STAFF REPORT: APRIL 12, 2023 MEETING

APPLICATION NUMBER: 23-8284

ADDRESS: 10321 OUTER DRIVE WEST

SCOPE: REPLACE WOOD WINDOWS

Applicant photos

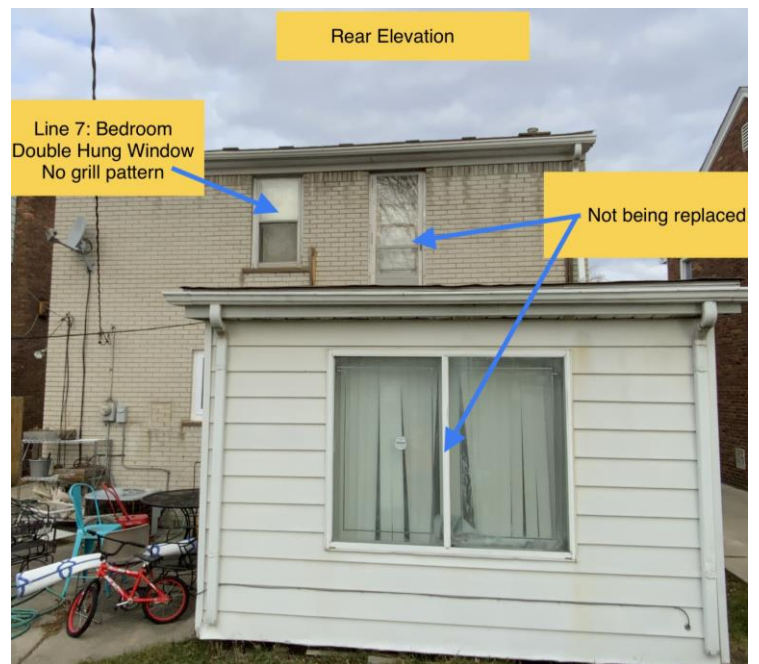
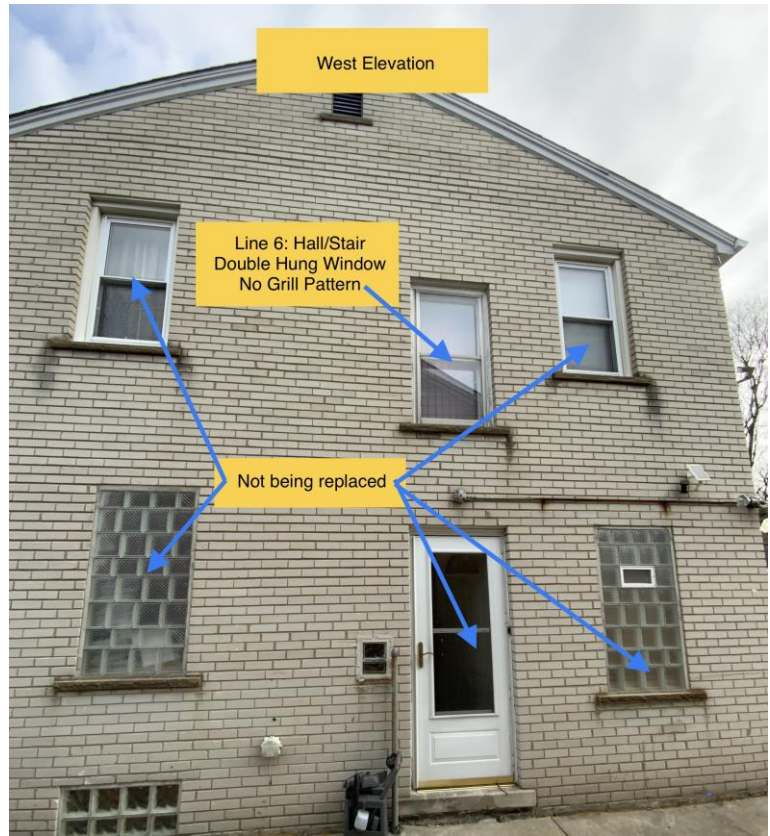
- The applicant stated, “*We are replacing the current windows because they are old, the wood around each window is rotted, and they are loose and falling apart.*” However, it is staff’s opinion, based on the interior photos submitted by the applicant, the sash is intact within each window opening and the wood frames don’t show visible evidence of significant deterioration.

- While Anderson markets Fibrex sash as a wood window, the majority of the material within the frames is plastic.
- The front elevation bay window is a distinctive character defining feature of the house. The existing wood windows contribute to this feature for the following reasons:

- True divided-light muntin bars offer a dimensionality to the window openings and is the dominant architectural detail on the structure.
 - The cottage-style flanking units are not ubiquitous on houses, and adds a unique proportion to the front elevation.

- The window order states the bay window flanking units (window #s 4 and 5) will become picture windows. The description in window #4 isn't correct (it states four vertical bars-staff believes this is a typographical error); the description in window #5 is correct (four horizontal bars and one vertical bar) and would mimic the glass pattern in the existing windows.

- The operation of the existing cottage-style windows gives a dimensionality to the window sash that would be lost with the installation of casement units.

- The central fixed wood window has a custom feature in which the second horizontal bar is thicker, emphasizing its alignment with the meeting rails of the side windows. This difference in width is further evident in the interior picture provided by the applicant. While this different width is a small detail, it is staff's opinion it is these small details that contribute to the uniqueness of historic structures.

It is staff’s opinion that the existing wood windows are not deteriorated beyond repair and the wood sash at the front elevation retains a level of materiality and dimensionality that offers architectural detail to the structure. Therefore, staff recommends the Commission deny a Certificate of Appropriateness for the work as proposed because it does not meet the Secretary of the Interior Standards for Rehabilitation and the Elements of Design for the district, specifically Standards:

6) Deteriorated historic features shall be repaired rather than replaced. Where the severity of deterioration requires replacement of a distinctive feature, the new feature shall match the old in design, color, texture, and other visual qualities and, where possible, materials. Replacement of missing features shall be substantiated by documentary, physical, or pictorial evidence.
